Access Compliance Report

Public Rights-of-Way

(Curb Ramps)

Intersection ID: 44304	Main Street: KIEV_DR	Cross Street: MALLORY_TAYLOR_LN	Location: NW
ADA ID: DED6893EC279	Ramp Type: PerpDiag	Initial Pass/Fail: Fail	Overall Compliance: No
Severity Score: 8.75			
Codes/Mitigation Info/Possible Solution		Field Measurements/Component Compliance

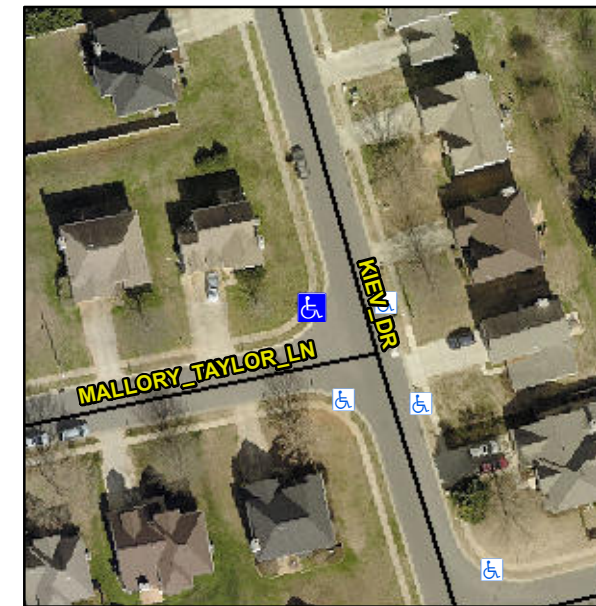
Not Found, R304.5.1

Remove & Replace Curb Ramp With Two New Directional Ramps or Equivalent.
